UNITED STATES  
NUCLEAR REGULATORY COMMISSION  
WASHINGTON, D. C. 20555

MEMORANDUM TO: R. Mattson  
V. Stello

SUBJECT: TMI-2 PLANT MODIFICATIONS FOR COLD SHUTDOWN  
(SEE APPENDIX)

TMI-2 PLANT MODIFICATIONS  
FOR ACHIEVING COLD SHUTDOWN\*

**FIGURE 1**

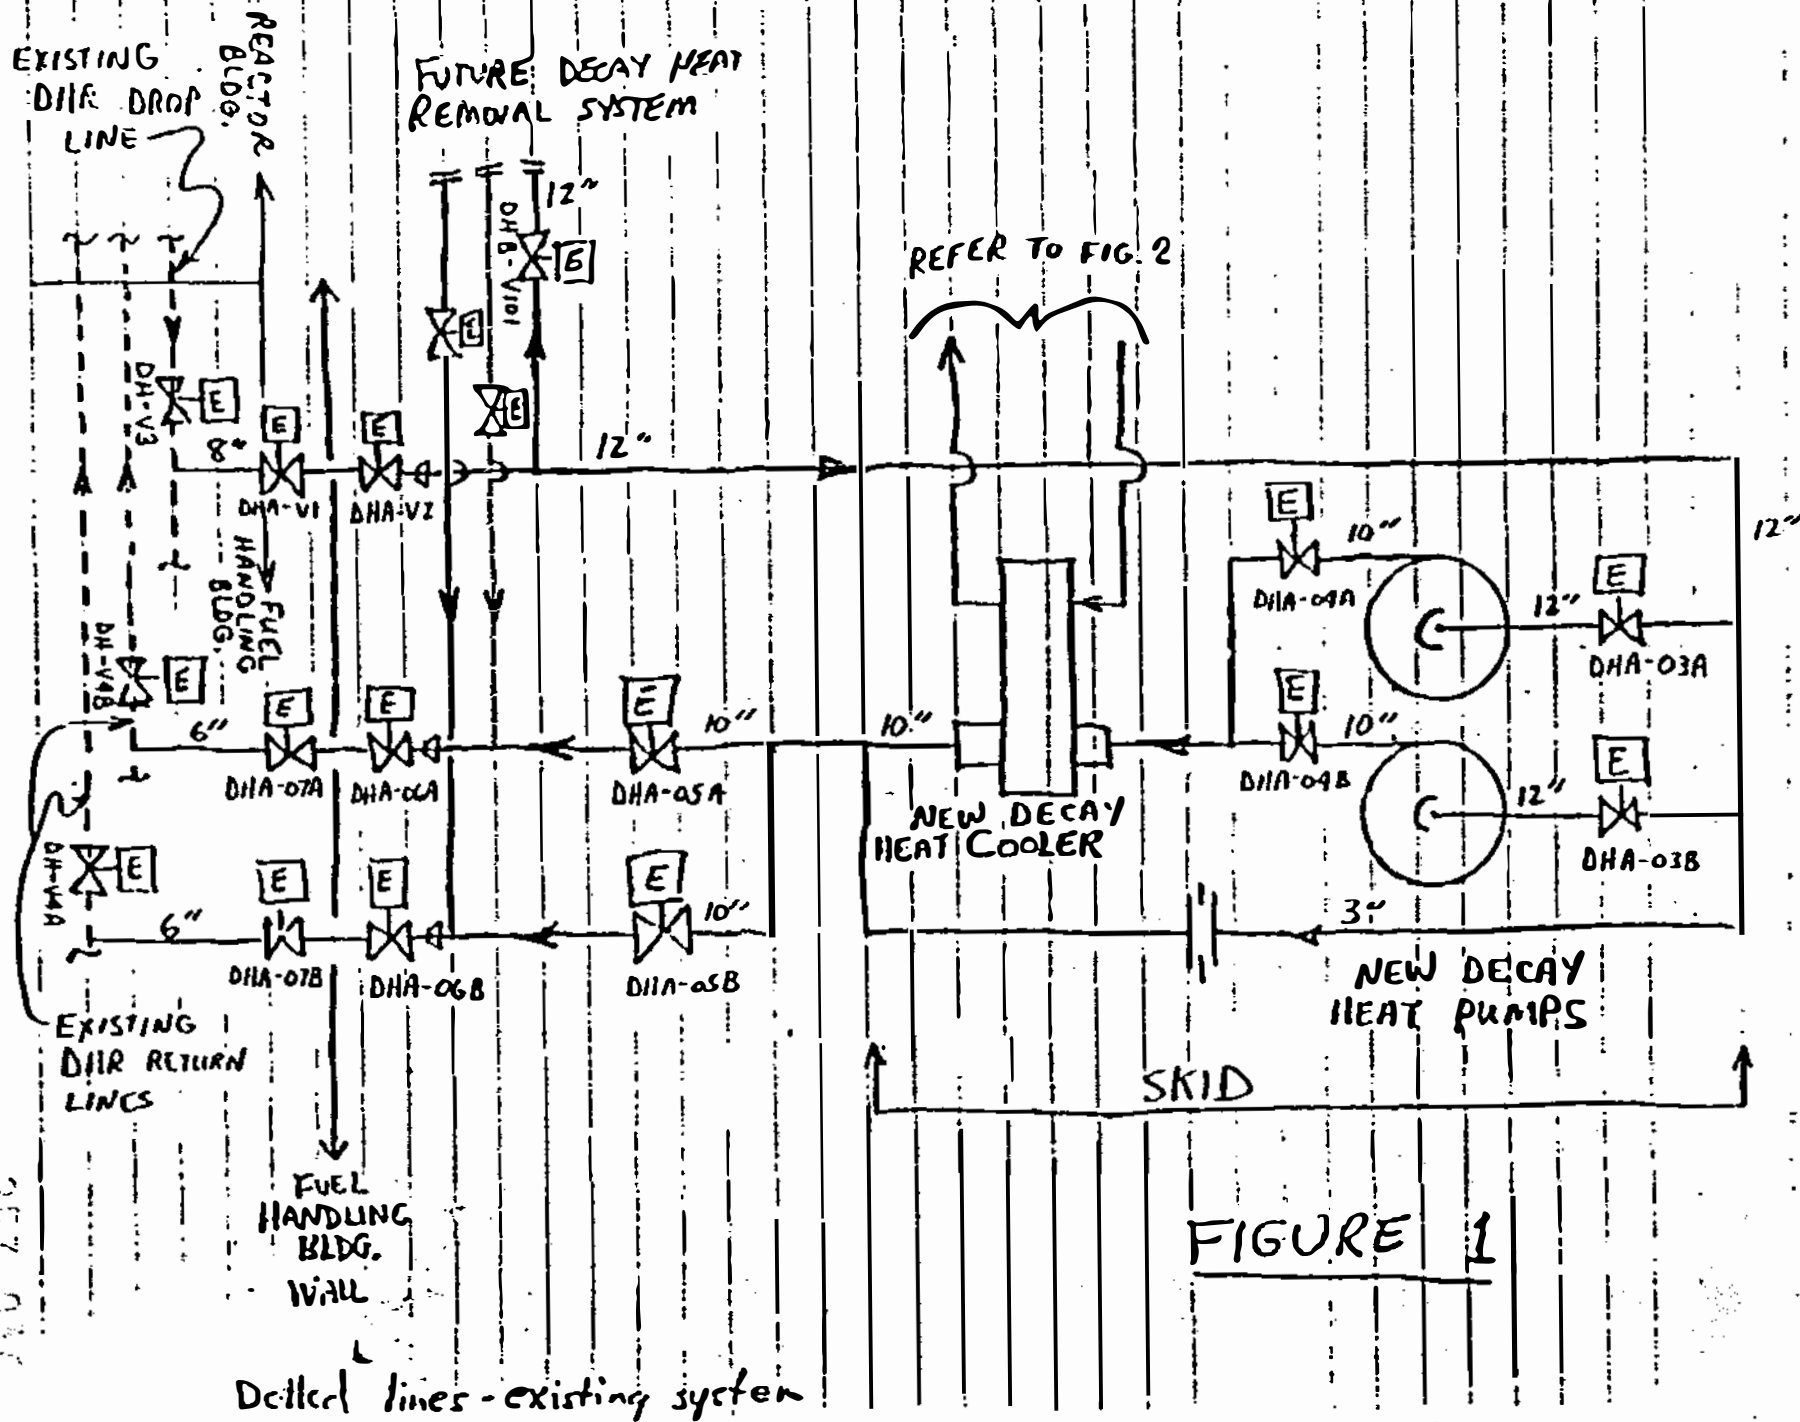
A third train for decay heat removal will be provided. This will involve a tie into the existing decay heat removal system drop line downstream of valve DH-V-3 located in the fuel handling building and ties into the two return lines to the cold leg also located in the fuel handling building (See Figure 1). New lines will be run through the penetration room to an opening cut in the fuel handling building wall and out to a skid located outside the building at grade elevation (304'-6"). This skid will contain a new decay heat removal heat exchanger and two full capacity pumps. The discharge line for the heat exchanger will return through the opening in the fuel handling building to the return line tie-ins. The tie into the decay heat removal drop line will be made by welding an 8 inch weldolet to the pipe with a full penetration weld, dye penetration testing the weld, then cutting the hole in the pipe using a plasma arc cutting process to minimize debris and finally welding the new pipe to the weldolet. A similar procedure would be used for the tie-ins to the two return lines. This procedure should minimize the time that the decay heat removal system will be out of operation. All valves will be electric motor operated and will have two seals with provisions for collecting leakage and directing it to the existing rad-waste system. Additional connections will be provided in the new piping outside the fuel handling building for future use in the installation of a dedicated, long life, hardened structure which will contain heat

Figure 2

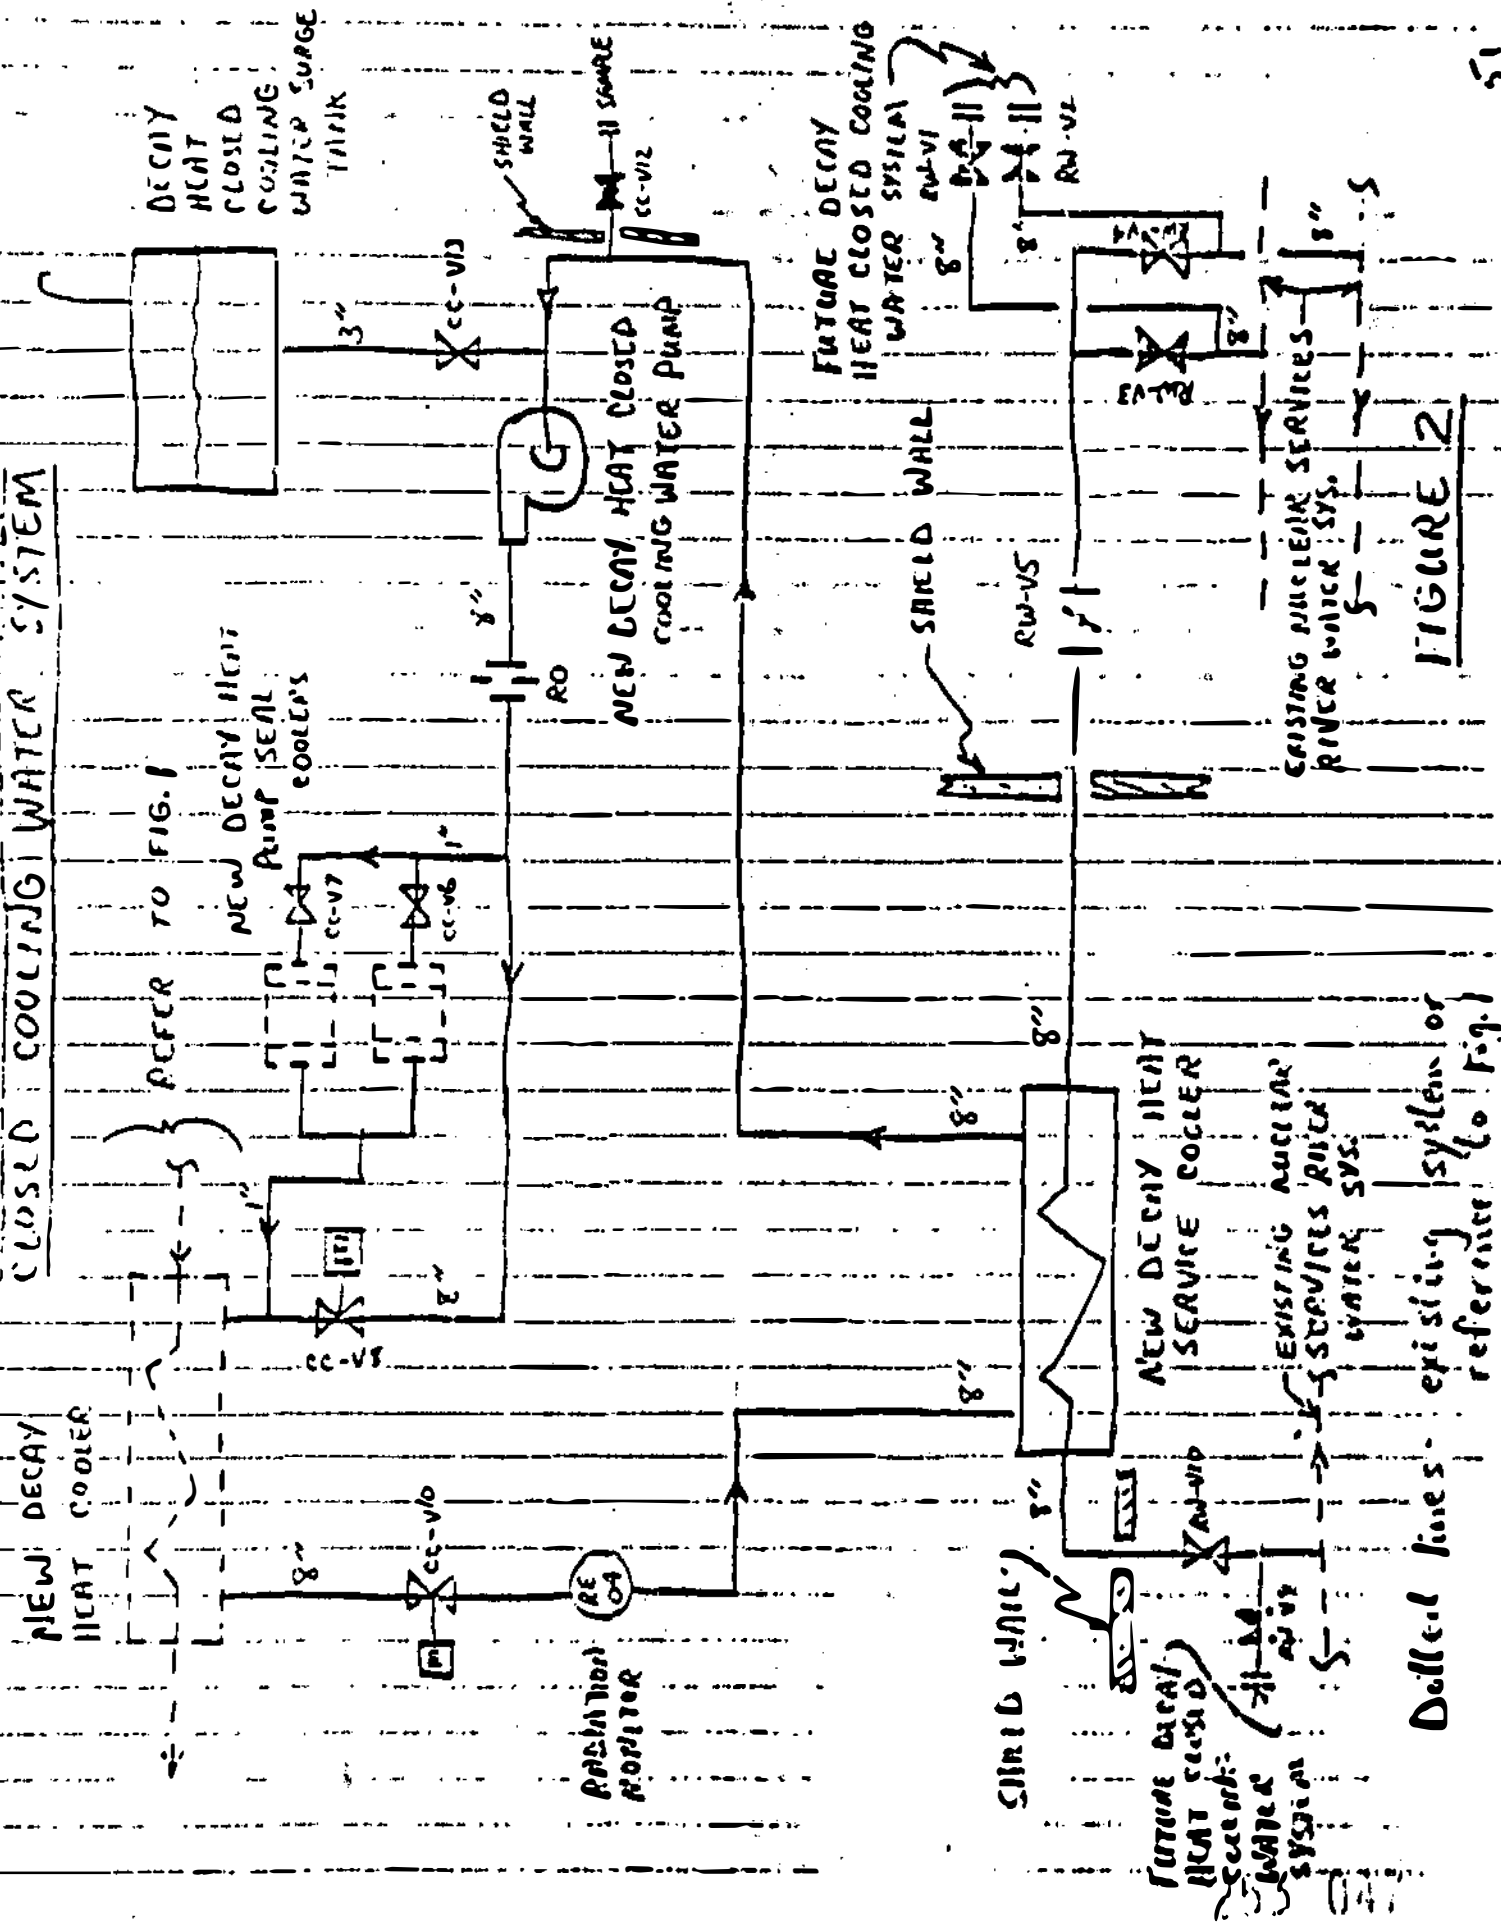
The secondary side of the new decay heat removal heat exchanger will be cooled by a new separate decay heat closed cooling water system with its own pump, piping and valves. (See Figure 2). This system in turn will be cooled by water from the nuclear services river water system. New connections will be made to this system.

FIGURE 3  
Sketch Showing  
Penetration through  
Auxiliary Side Wall.

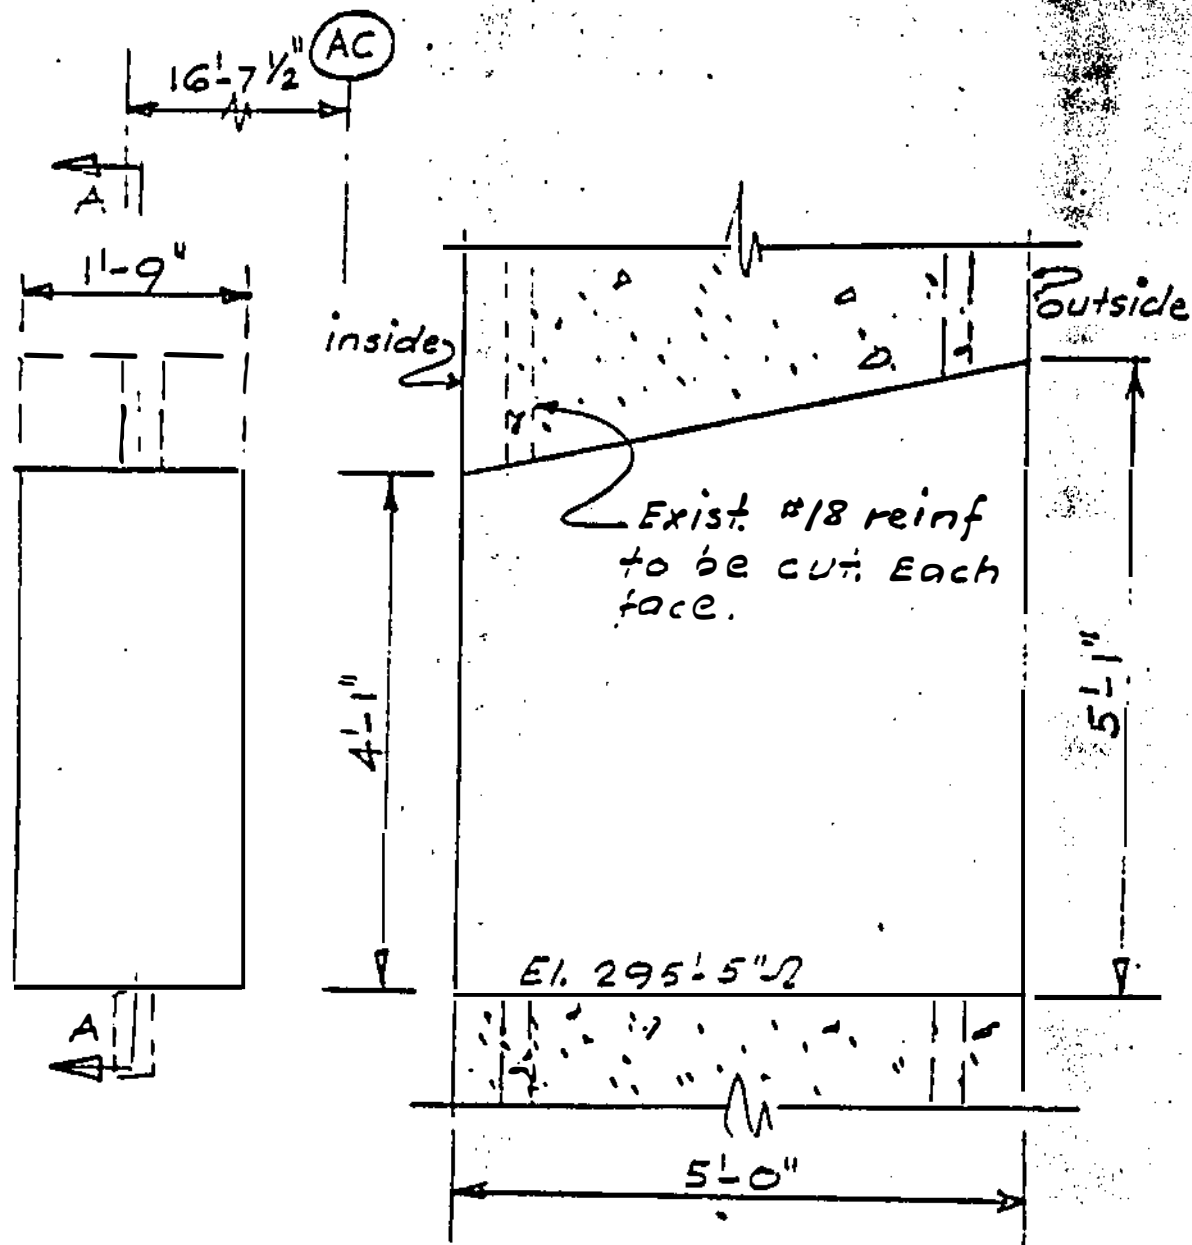
In order to provide the skid mounted decay heat removal system a penetration would have to be made through the west wall of the Fuel Handling Bldg., between column lines AC and AF and across column line A69, at elevation 297'-0" (See B&R Drawing 2075). This is approximately seven feet below grade. Excavation outside of the structure will be done by pick and shovel to minimize a possibility of damaging any piping or electrical conduit. The outside wall at that location is reinforced concrete, 5'0" thick. The compressive strength of concrete in this wall is 5000 psig.

The opening is to be made 21" wide 5'11" high on the outside tapering to 4'-11" at the inside face. One reinforcing bar, #18 is to be cut at each face. Figure 3 shows the front view and the cross-section at the opening.

At the time of writing of this report various methods of penetration are being studied. One possibility is using the oxygen lance process. A trial penetration is currently being performed by this method. Drilling through the wall is also considered. The final method of the wall penetration will be described upon pending results of the test and consultation with the other experts in the field of construction materials.
